RE: **Enchantment Carpet Addition**
4815 McLeod NE
Grading Plan
Engineer's Stamp Date 3/1/18
Drainage File: F17D099

Based on the information provided in your submittal received 3/2/18, the Grading Plan cannot be approved until the following are addressed:

ENGINEER'S SEAL  3/1/18	4815 McLEOD ROAD NE	DRAWN BY WCUJ
	GRADING AND DRAINAGE PLAN	DATE 2-28-18
		21860-LAYOUT-2-28-18
DAVID SOULE P.E. #14522	 <i>Rio Grande Engineering</i> 1606 CENTRAL AVENUE SE SUITE 201 ALBUQUERQUE, NM 87106 (505) 872-0959	SHEET # JOB # 21801

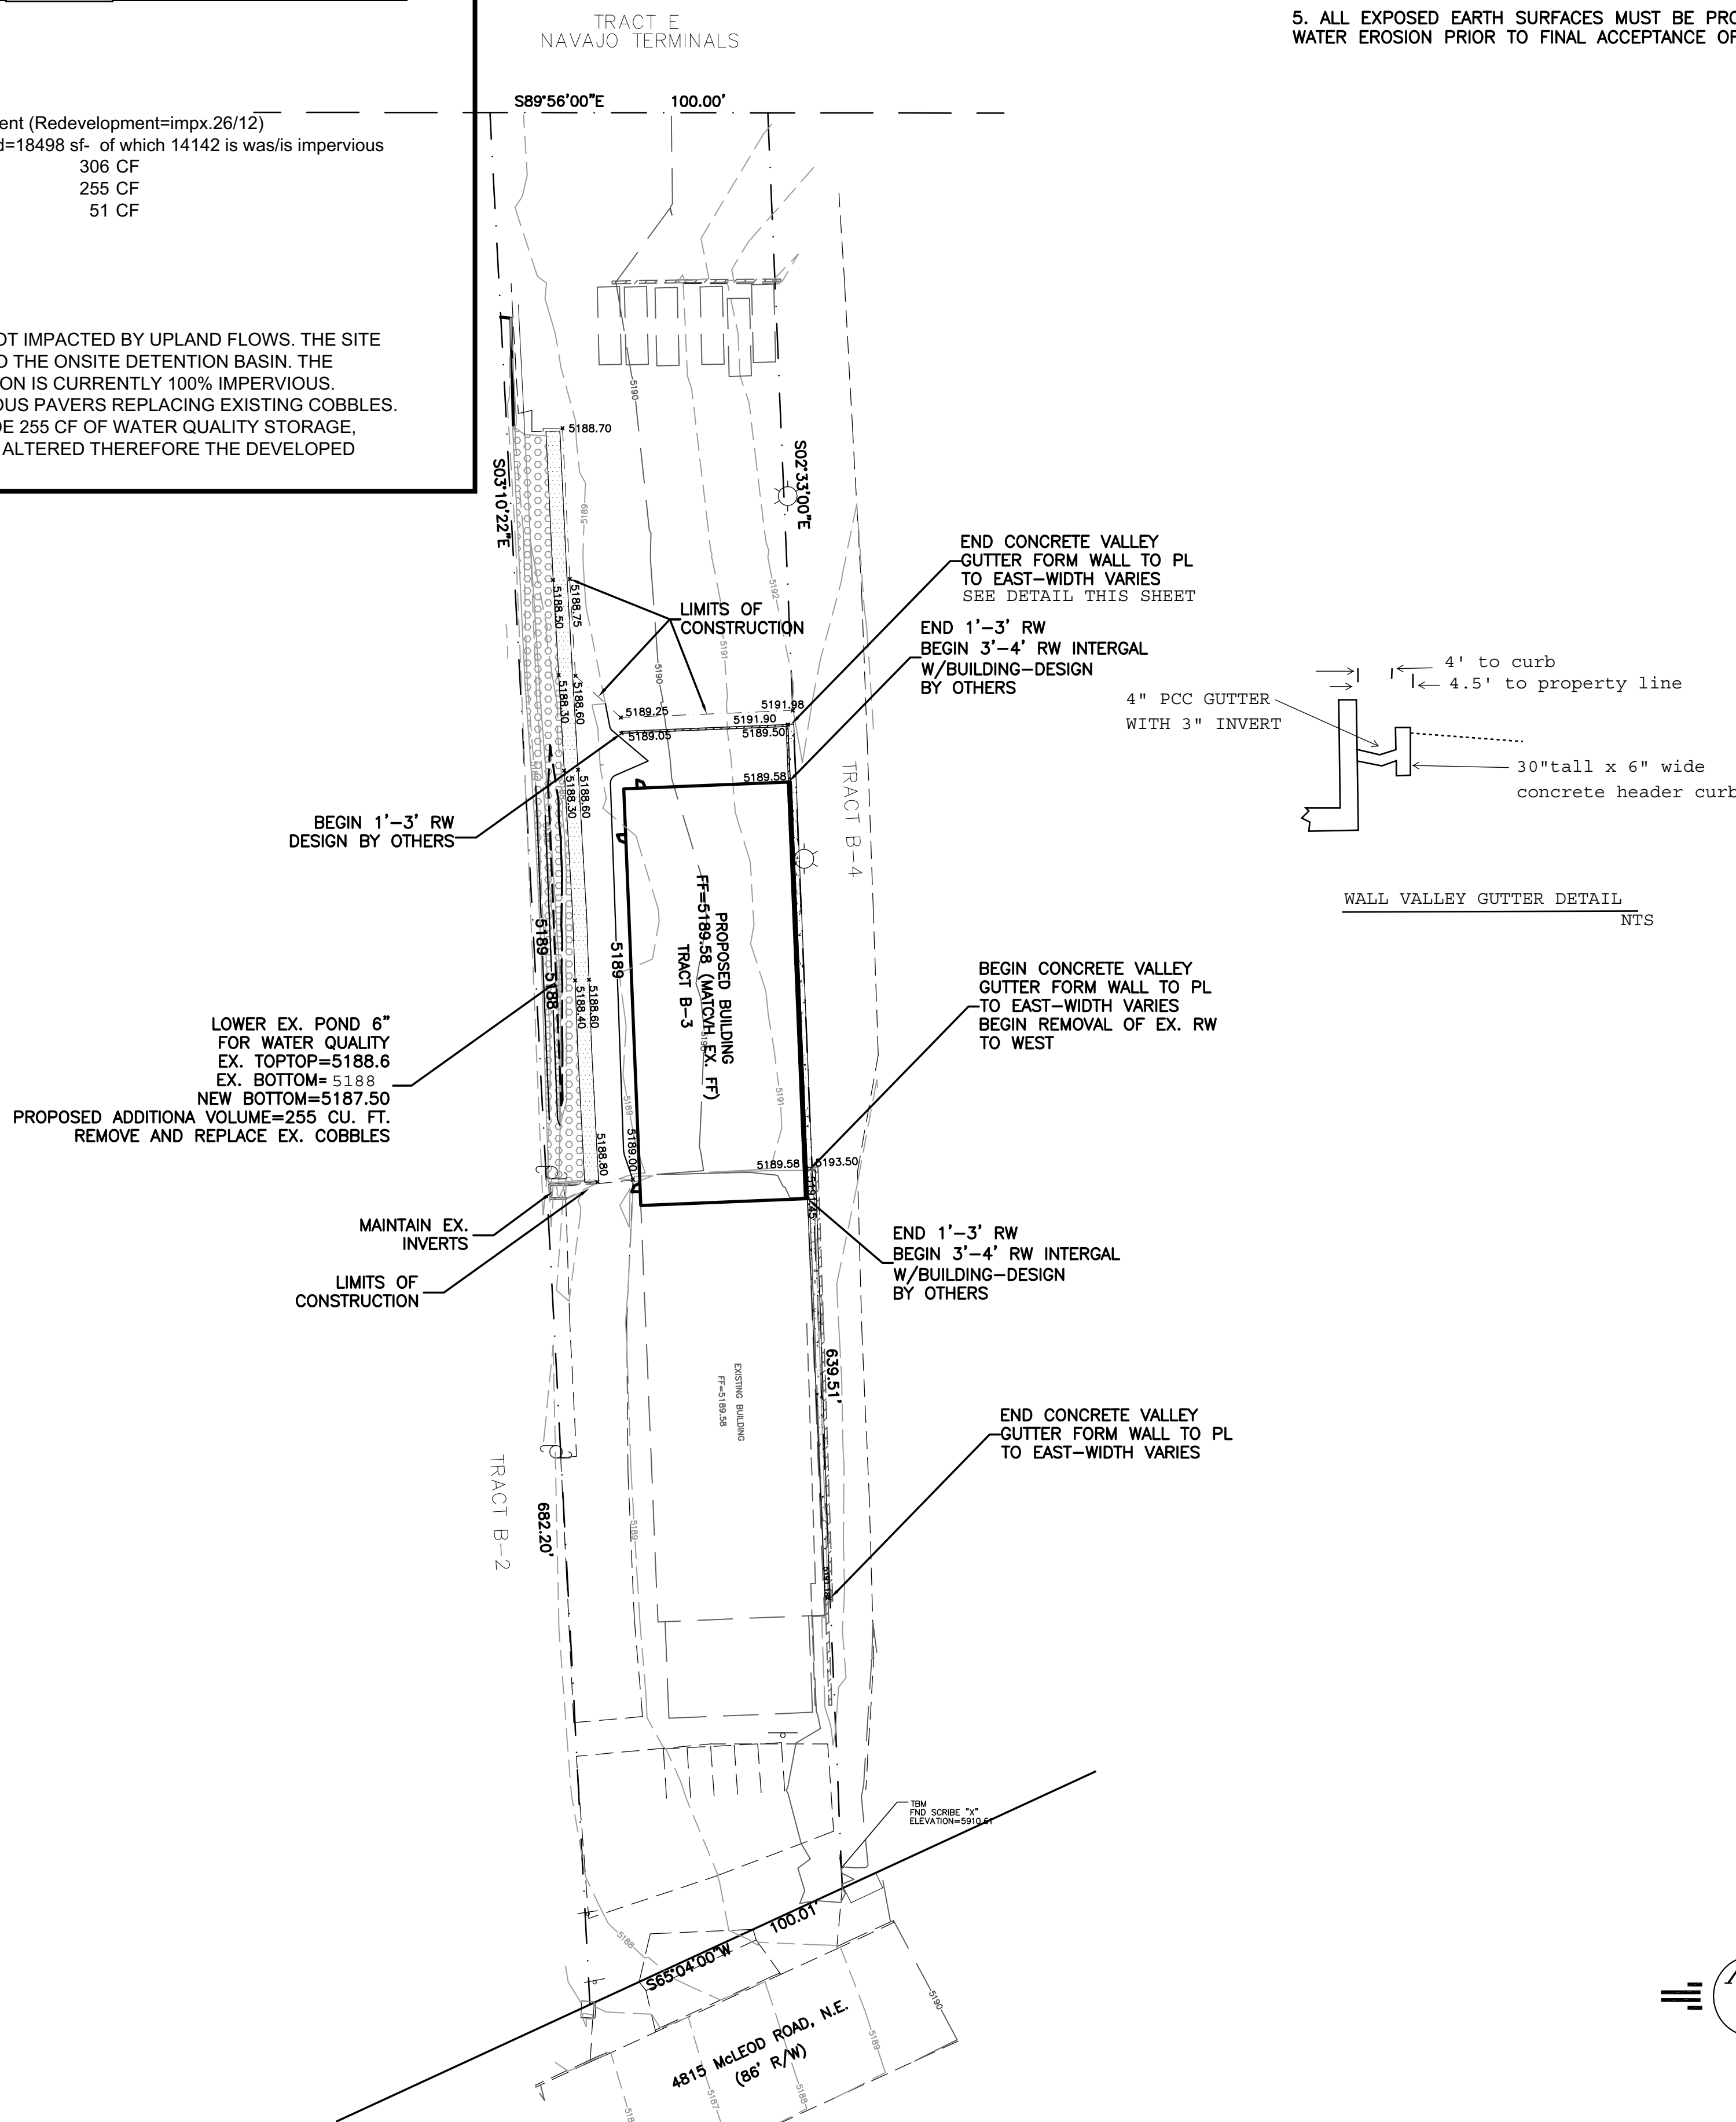
1. Payment of the Fee in Lieu (Amount = 51CF x \$8/CF, per Grading and Drainage Plan) for the required first flush volume must be made.
2. A Private Facility Drainage Covenant is required for the stormwater quality pond. The original notarized form, exhibit A (legible on 8.5x11 paper), and recording fee (\$25, payable to City of Albuquerque) must be turned into DRC (4th, Plaza del Sol) for routing. Please contact Charlotte LaBadie (clabadie@cabq.gov, 924-3996) or Madeline Carruthers (mtafoya@cabq.gov, 924-3997) regarding the routing and recording process for covenants.
